**CITY OF WINTER PARK  
PLANNING AND ZONING BOARD**

**Staff Report  
September 5, 2017**

**SPR 17-07**     REQUEST OF HYATT DESIGN FOR APPROVAL TO CONSTRUCT A NEW 4,875-SQUARE FEET SINGLE-FAMILY HOME LOCATED AT 1074 MCKEAN CIRCLE ON THE CANAL BETWEEN LAKE MAITLAND AND LAKE VIRGINIA, ZONED R-1AA.

SITE PLAN

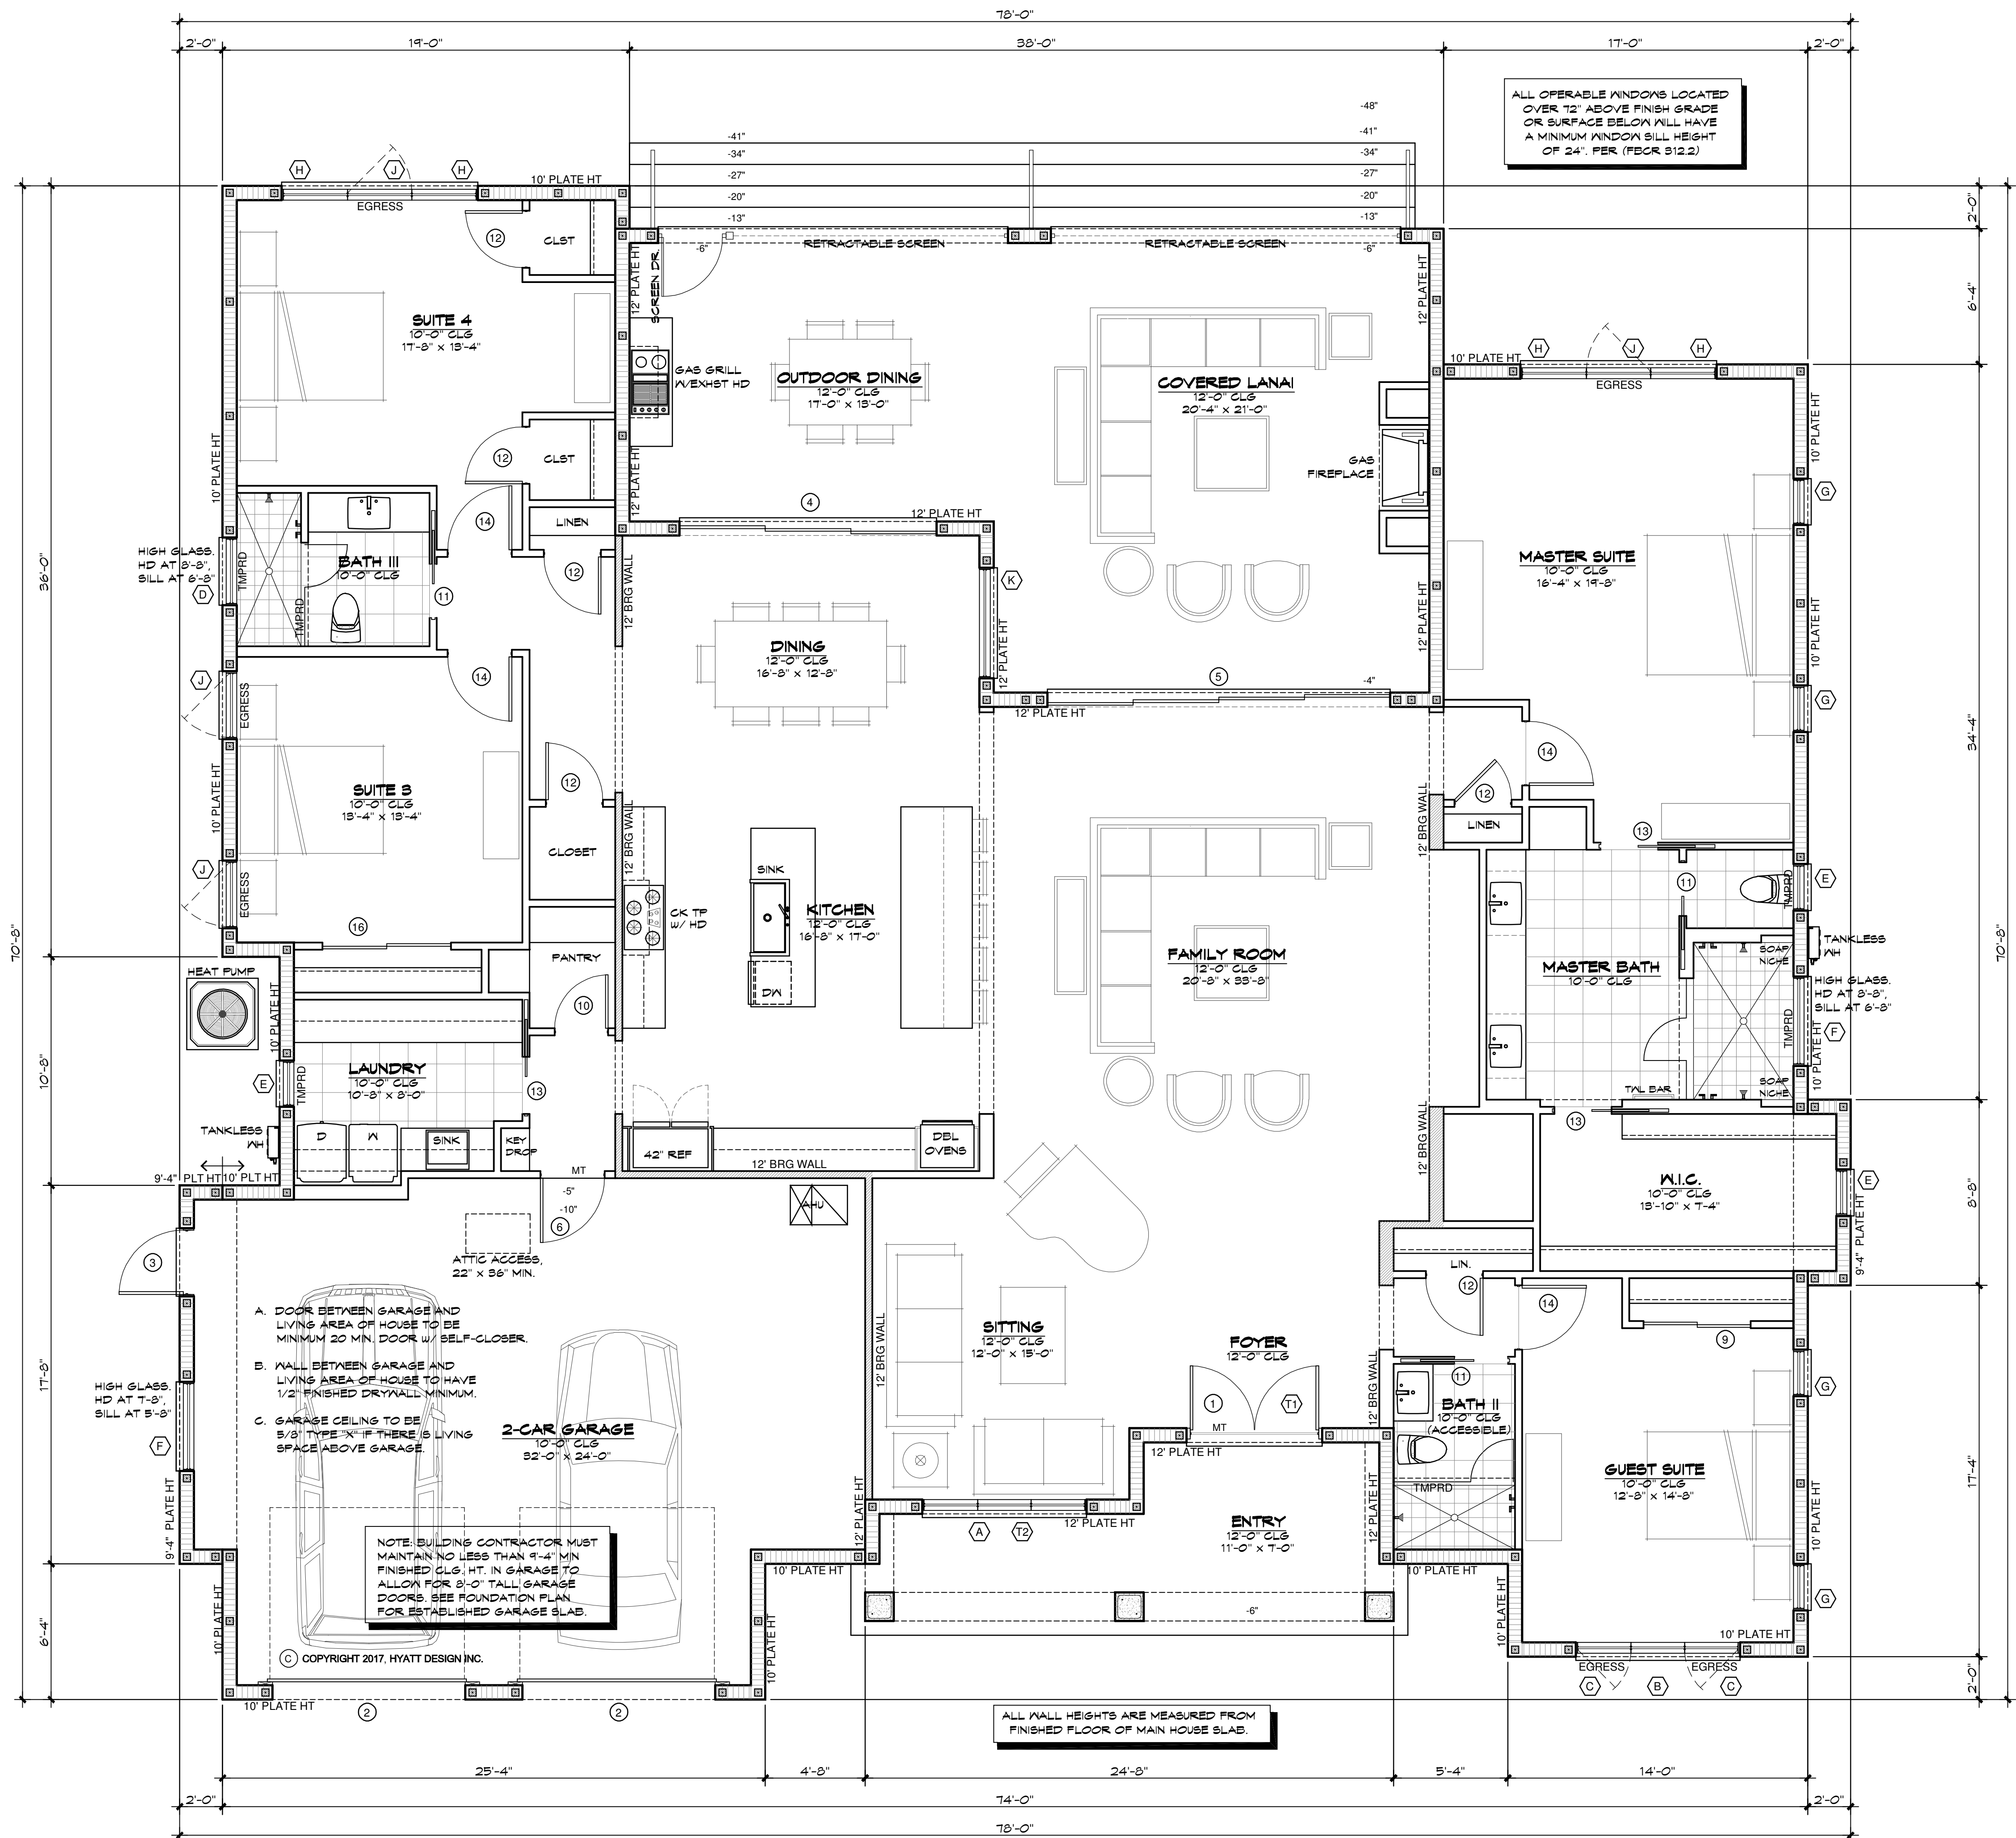
applicant is proposing three stormwater retention areas that are sized to meet the City's code requirement.
